Village of Arlington Heights
Plan Commission
Board Room
Arlington Heights Village Hall
33 S. Arlington Heights Road
Arlington Heights, IL 60005
January 24, 2018
7:30 PM

- A. 703-723 W. Algonquin Rd. - PC#17-013
PUD, Preliminary Plat of Subdivision

To: Plan Commission
Prepared By: Sam Hubbard, Development Planner
Meeting Date: January 24, 2018
Date Prepared: January 19, 2018

The existing peak hour vehicle traffic volumes (all vehicles) are shown in **Figure 4**.

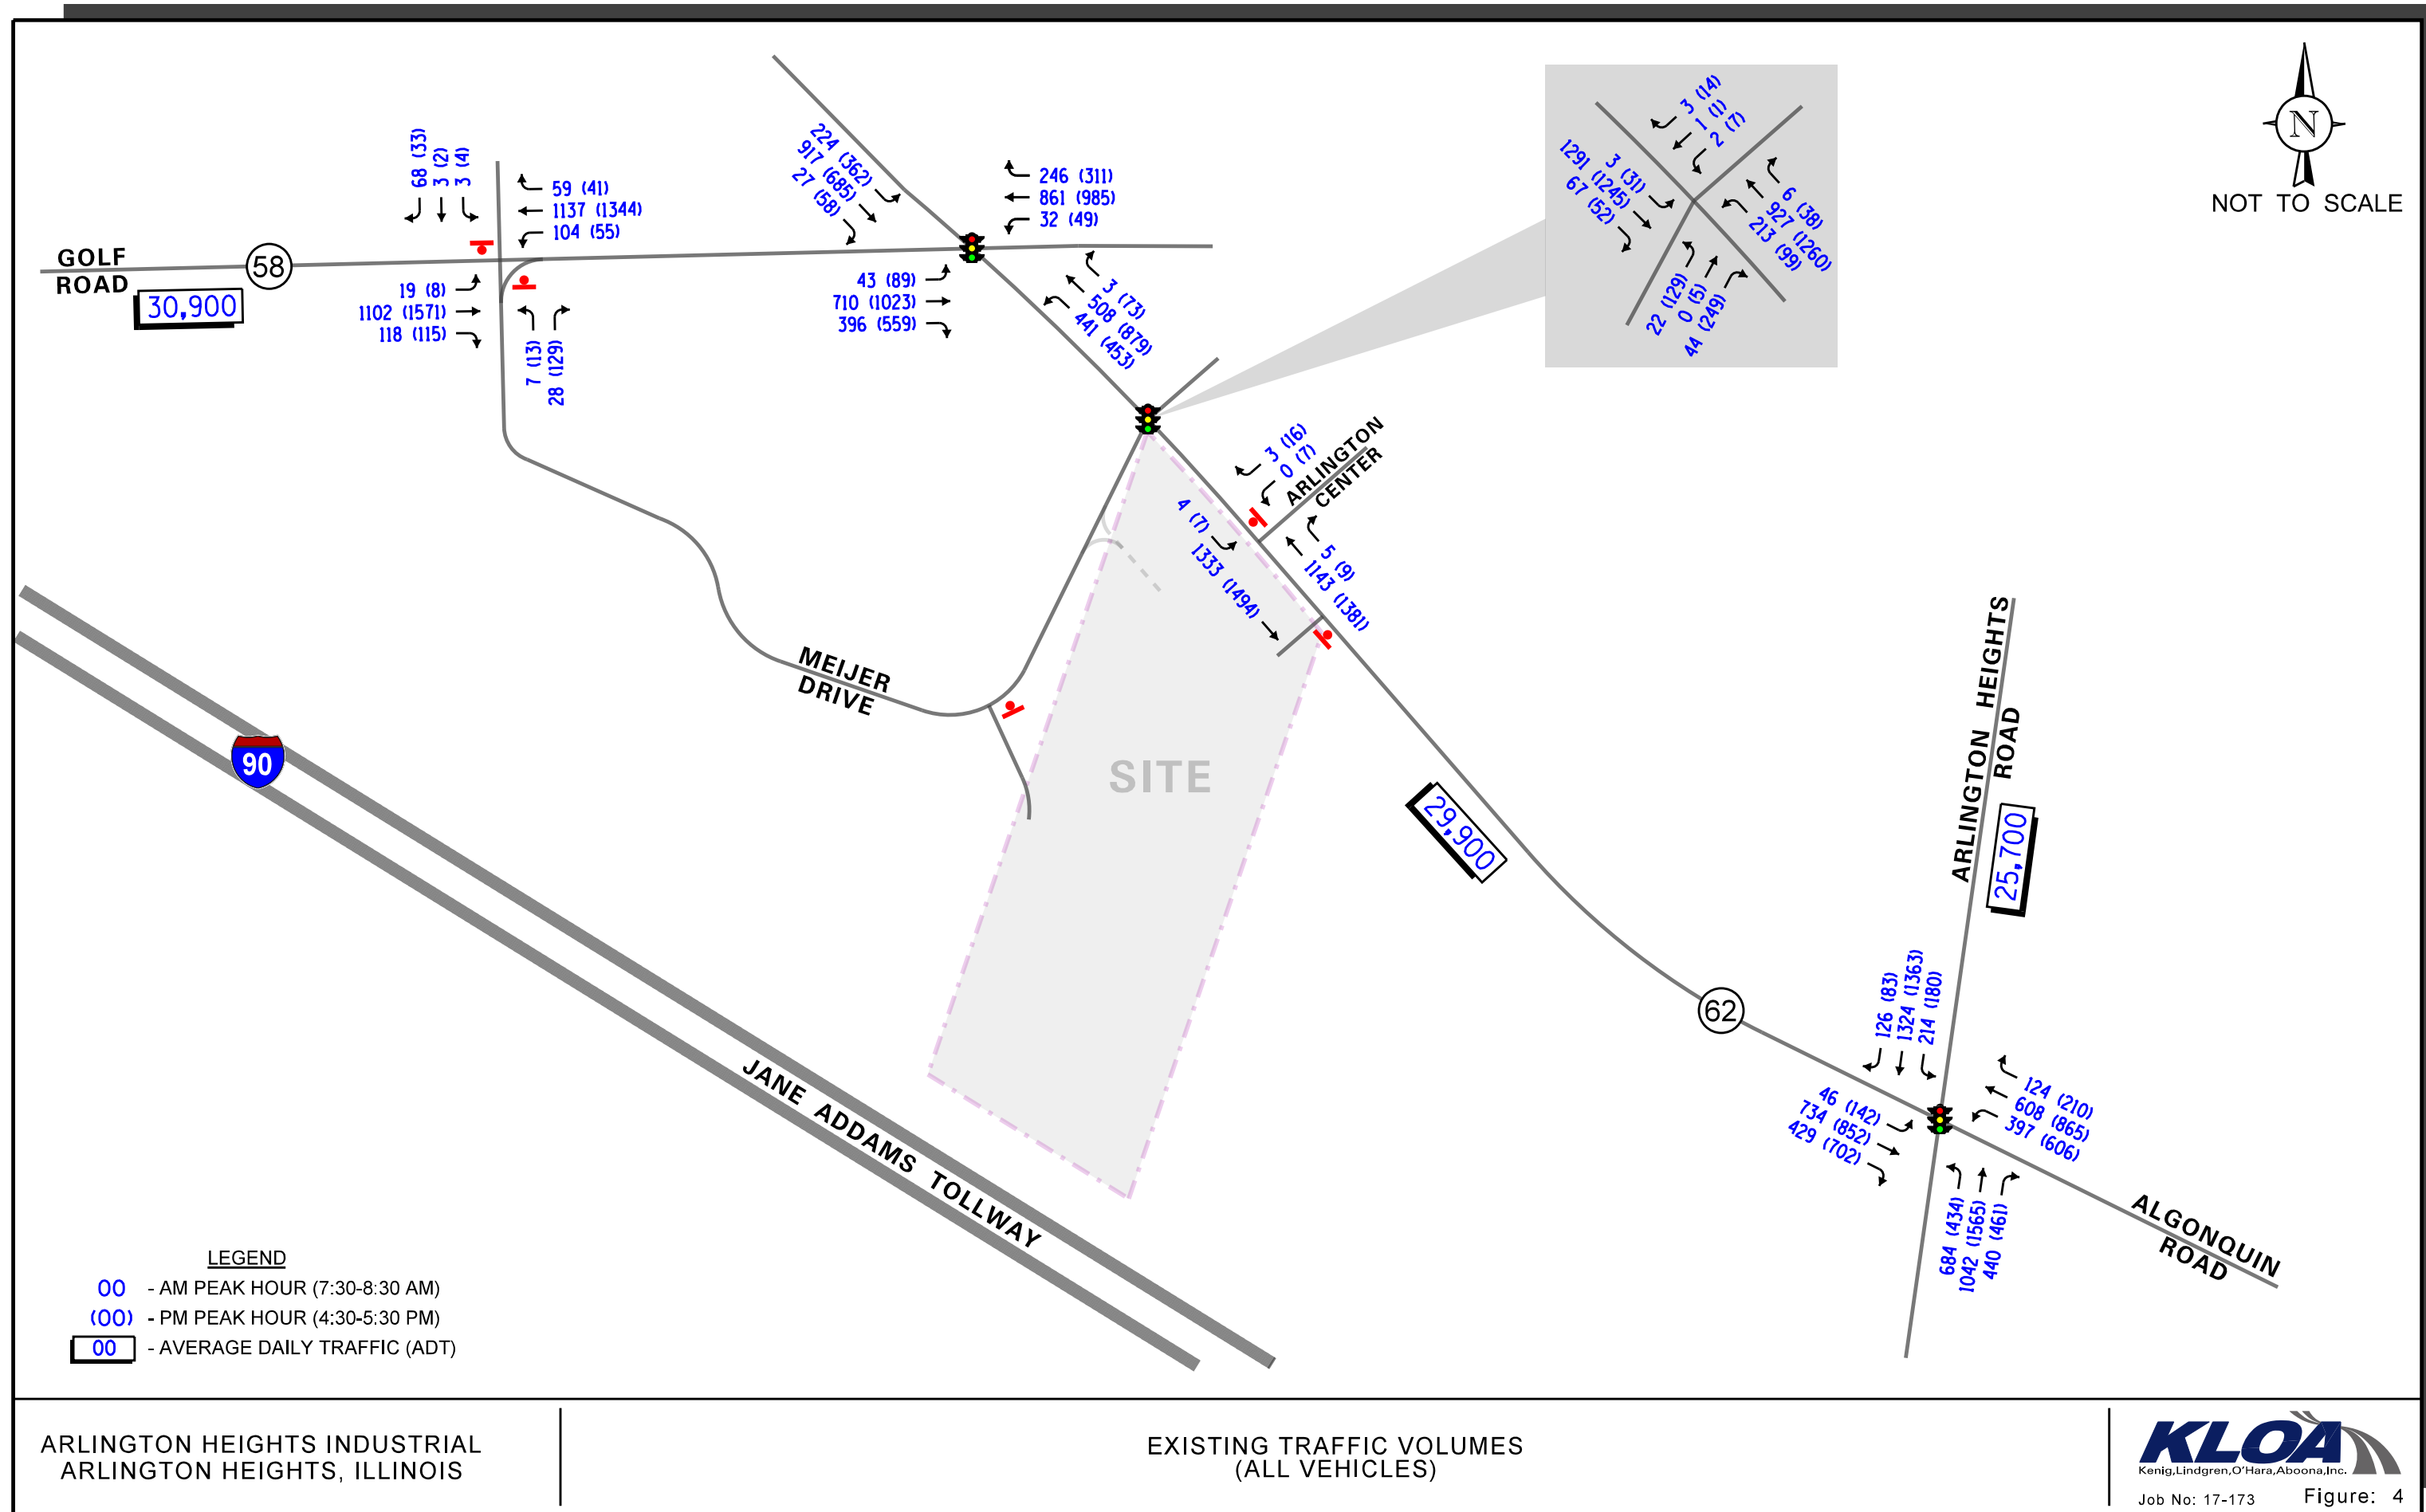
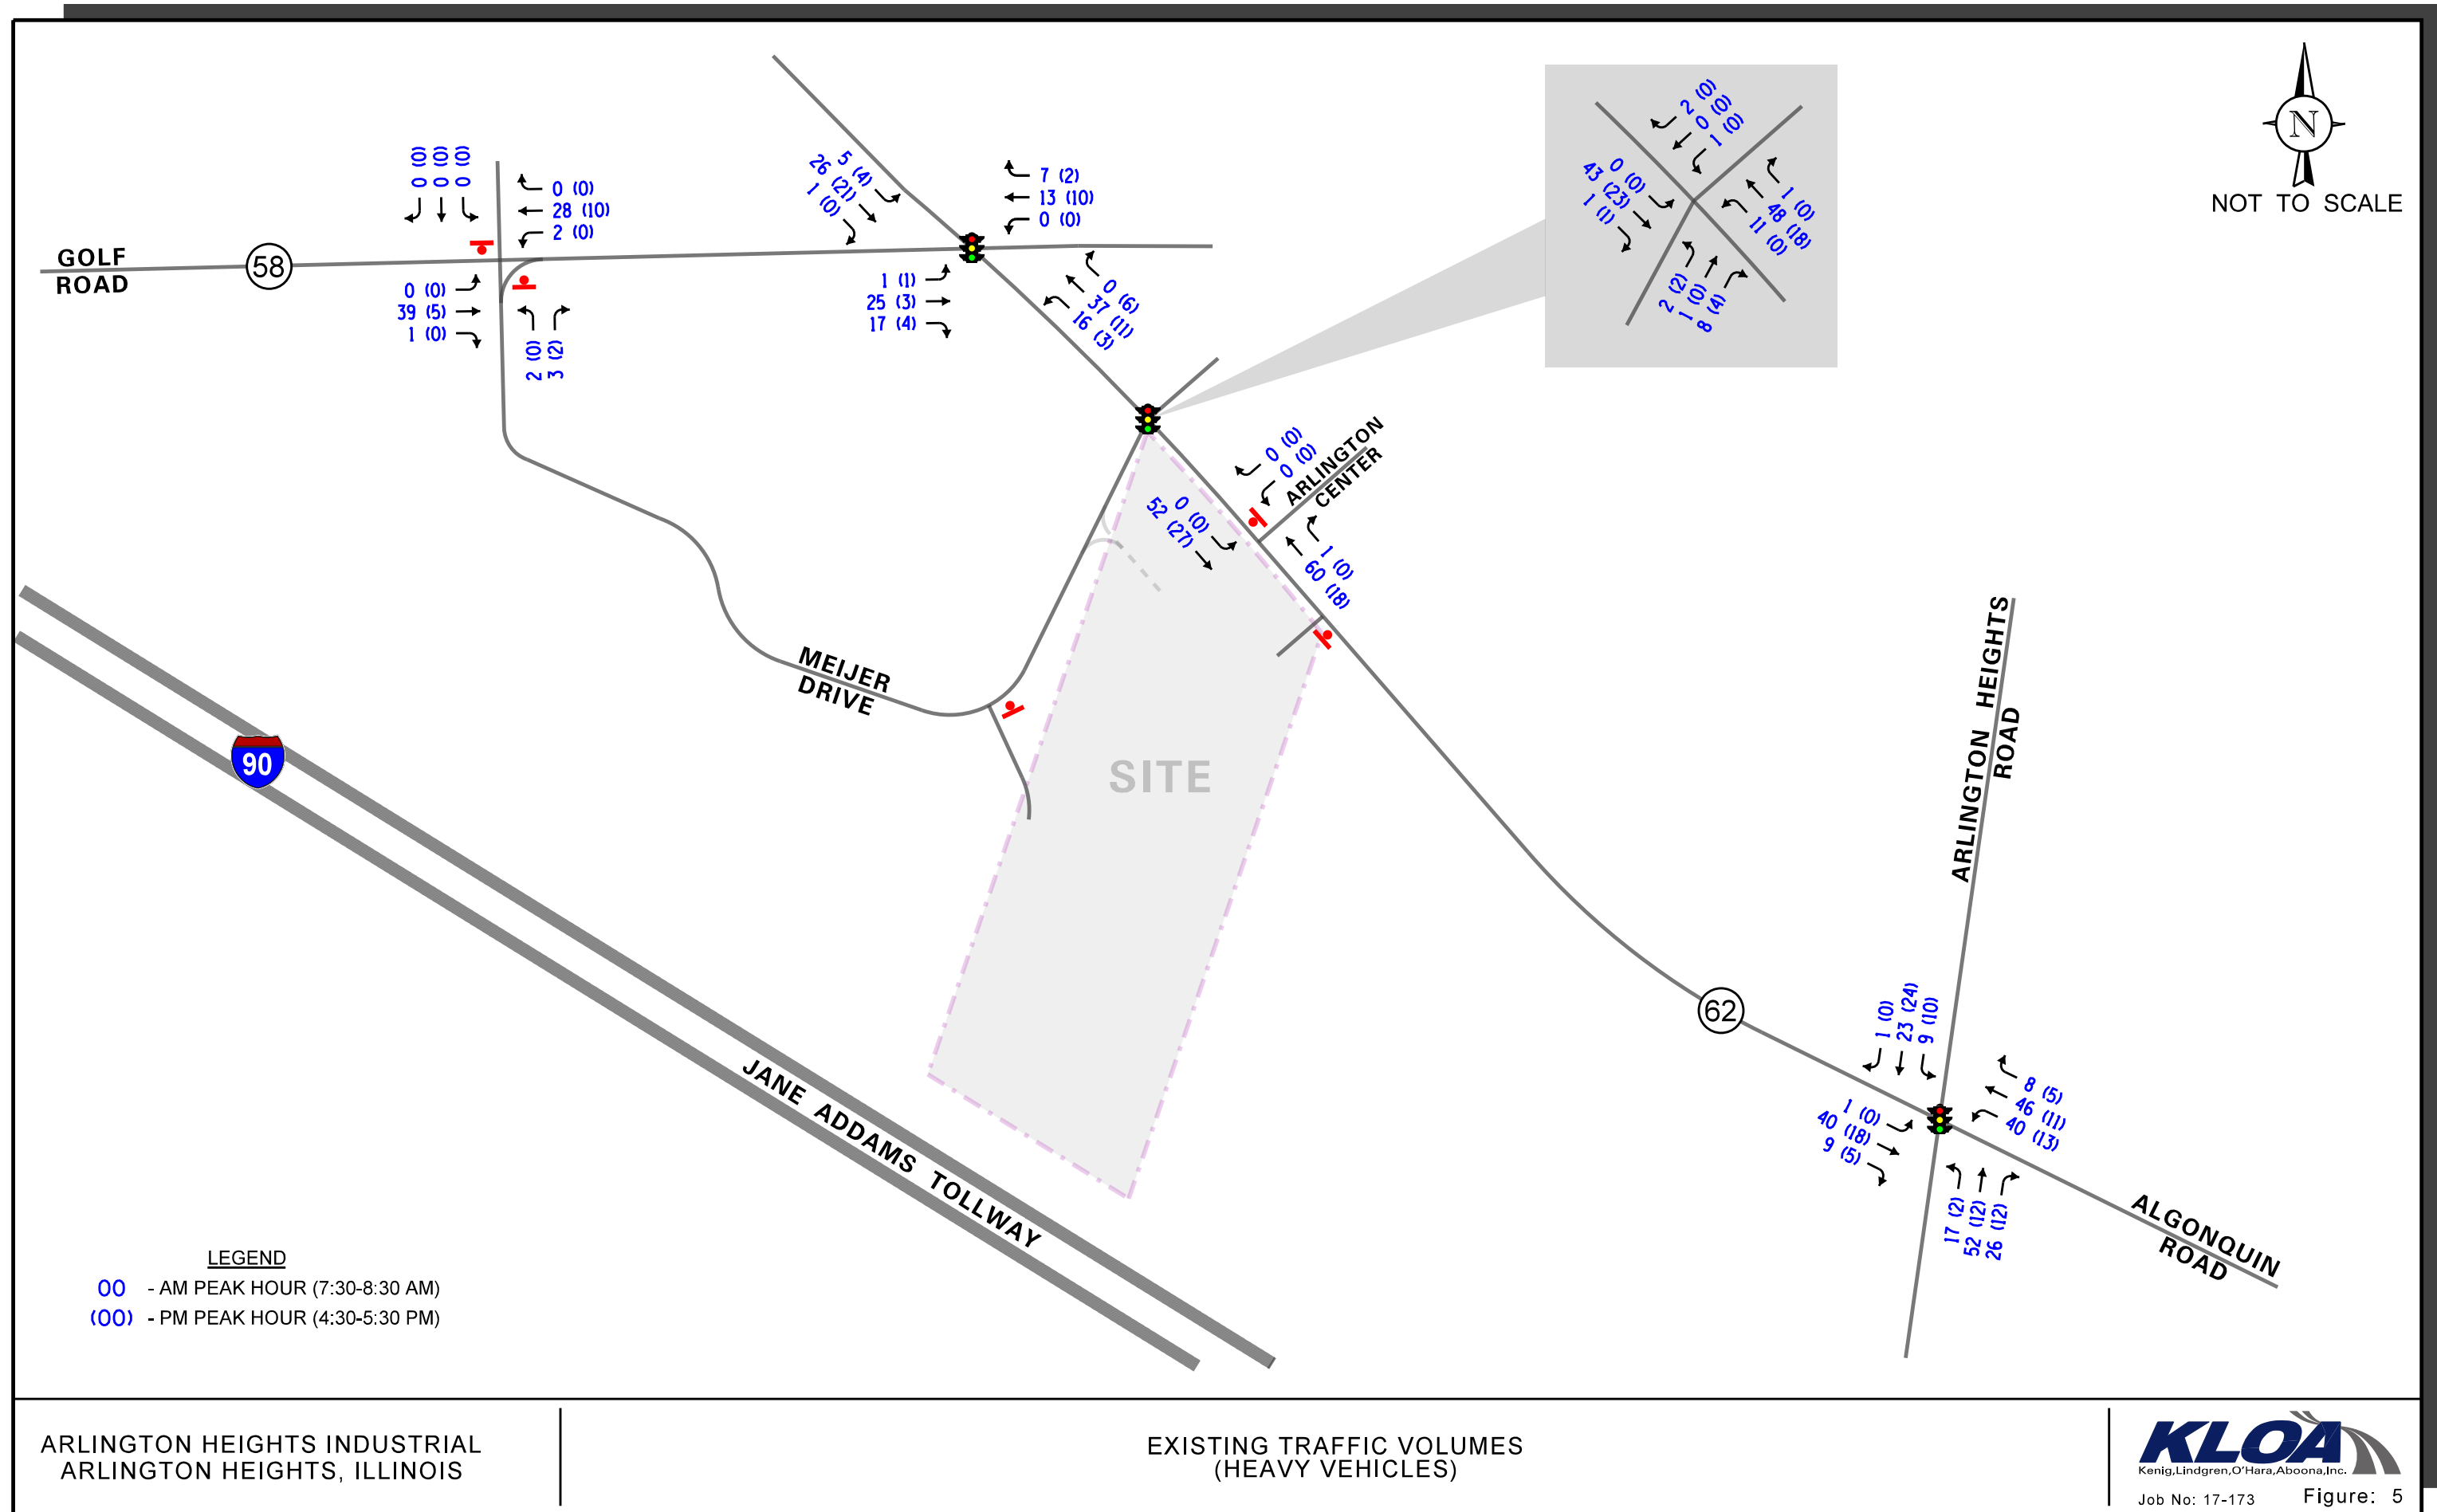
- 8) Please confirm, per figure 4 and 5 on pages 11 and 12 in the Traffic Impact Study, that there is currently no heavy truck traffic servicing the existing Oak Pointe property.

Figure 9 shows the assignment of the development-generated truck traffic volumes.

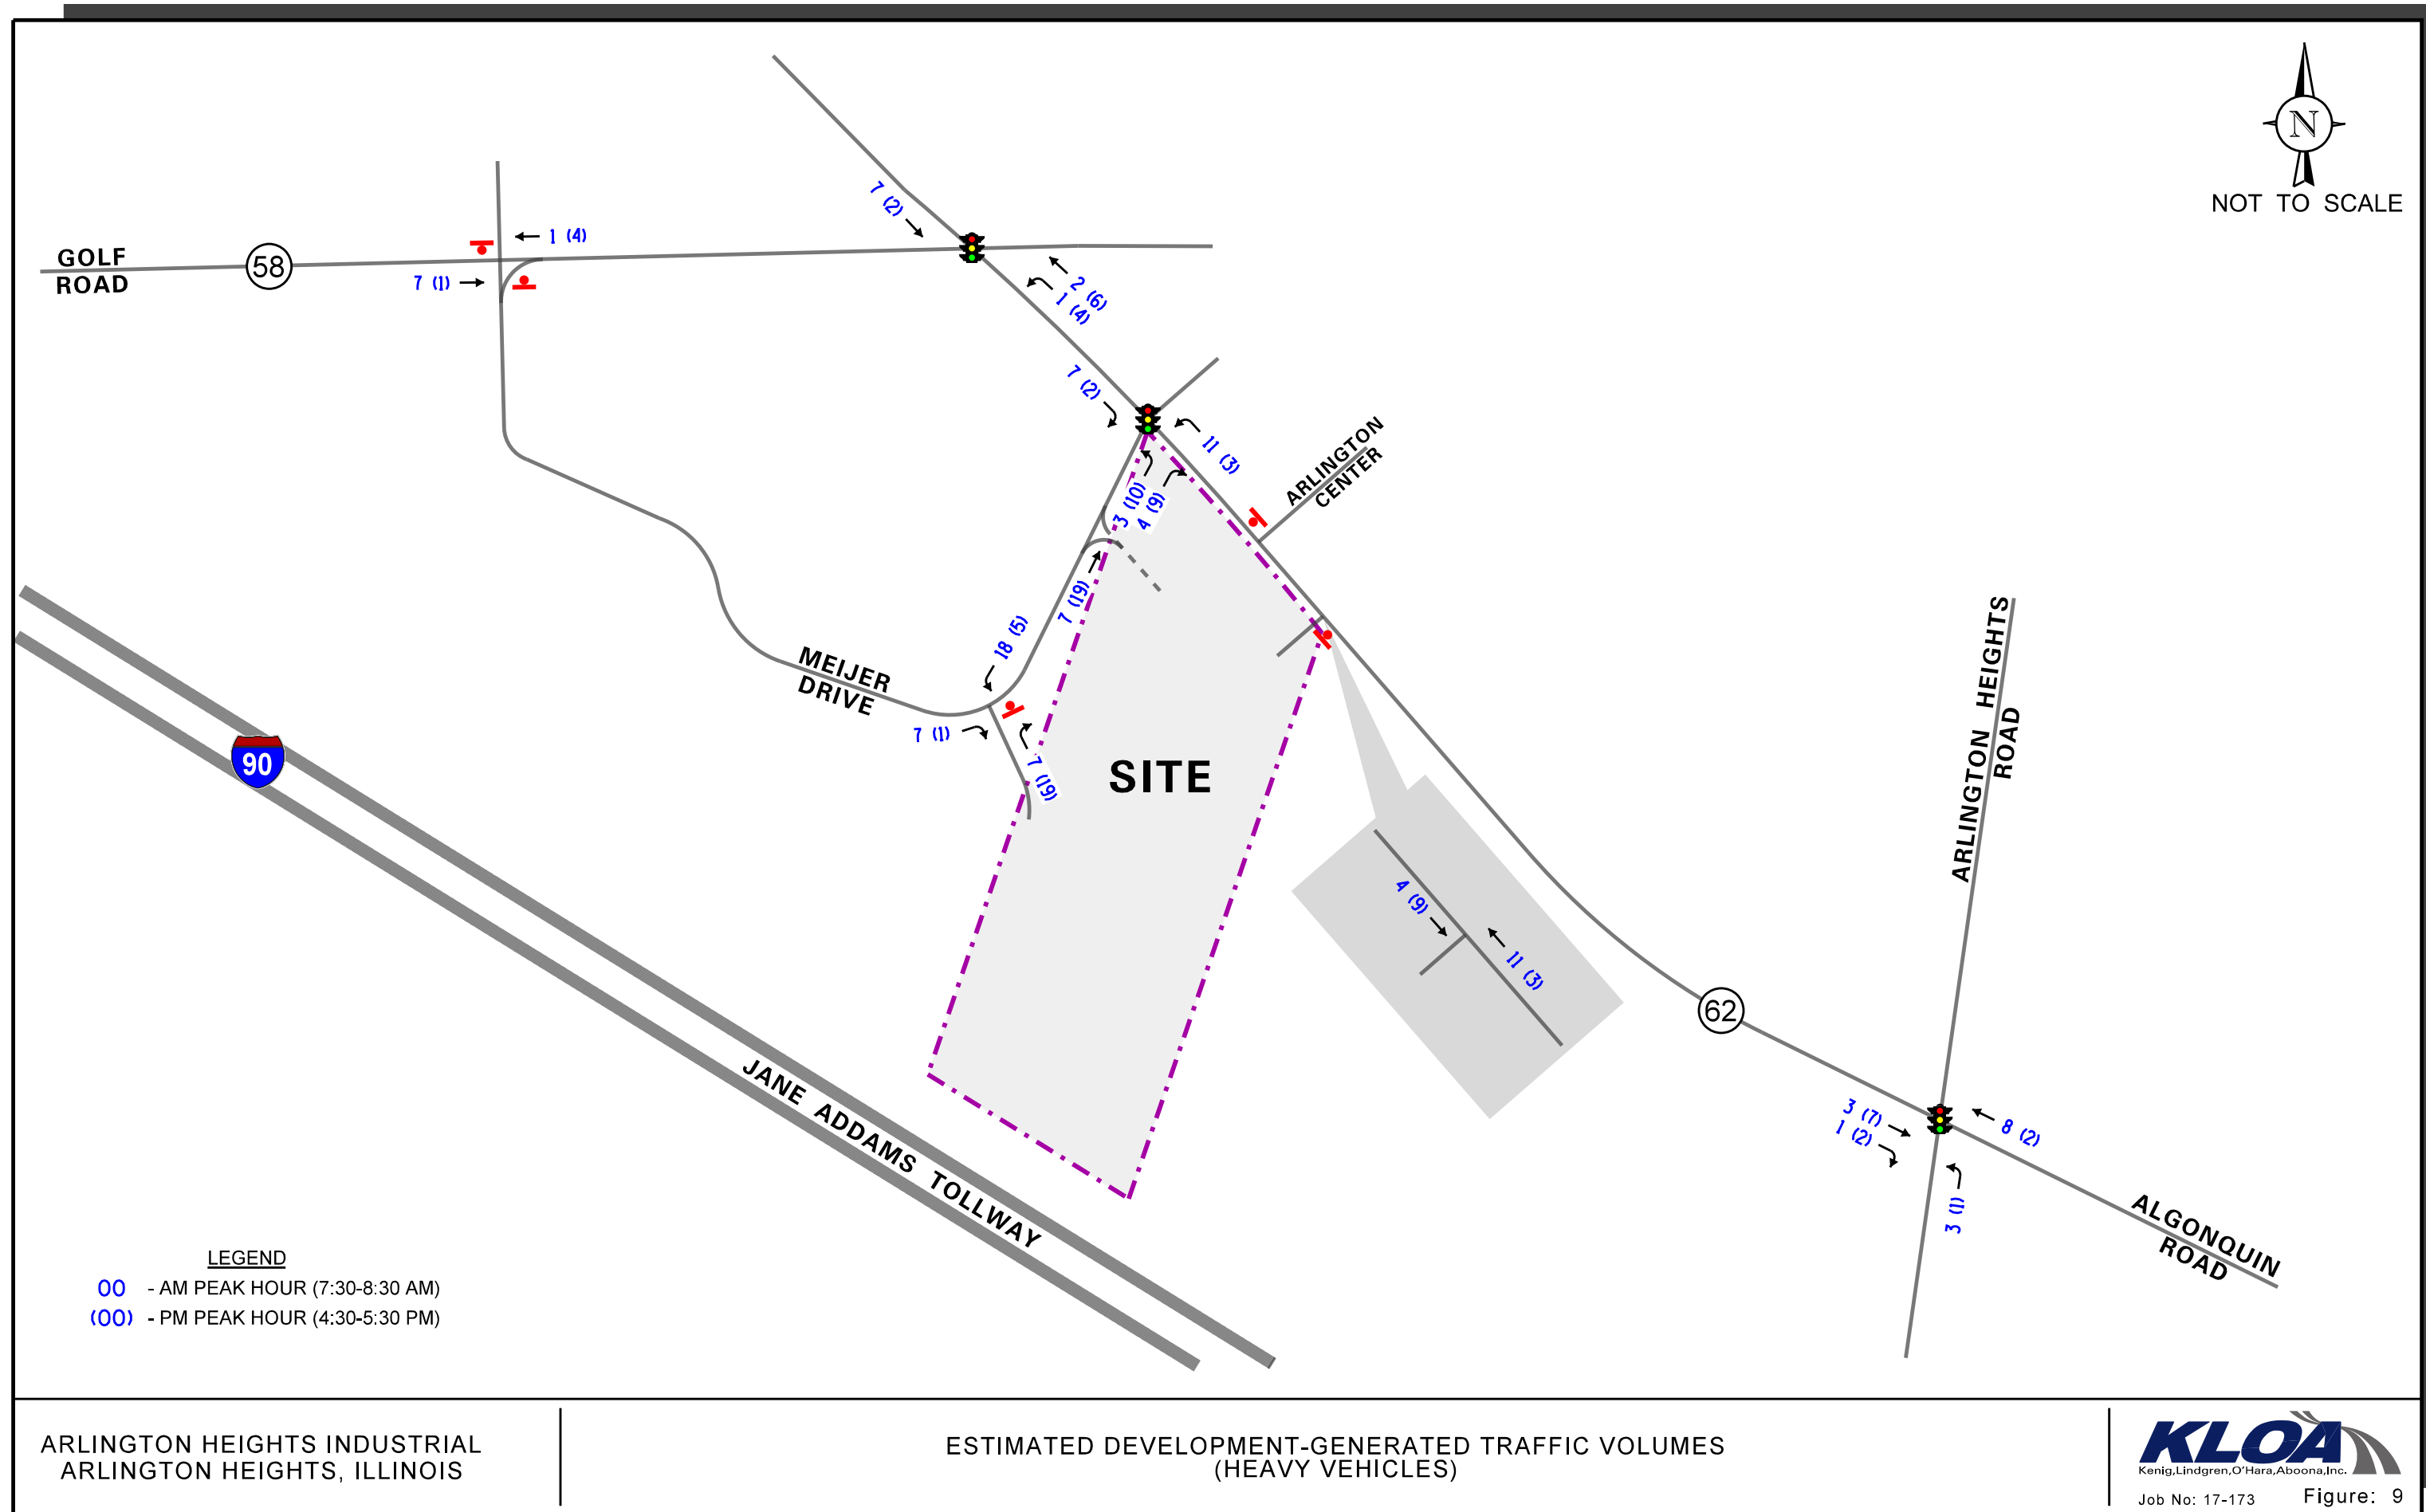
- 11) Figure 9 on page 20 shows "estimated development-generated traffic volumes of 31 vehicles entering the proposed development site, but only 26 vehicles exiting the site. Please explain.

11. Figure 9 (page 20 of the report) shows the development traffic assignment for heavy vehicles, which comes from Table 1 on page 17. The figure shows 25 and 6 heavy vehicles entering the site during the weekday morning and evening peak hours, respectively, as well as 7 and 19 heavy vehicles exiting the development during the respective peak hours.
12. Existing site drains to Northeast and will be maintained by the proposed development with no impact to Rolling Meadows.
- 13. Village of Arlington Heights**
- 14. Village of Arlington Heights**
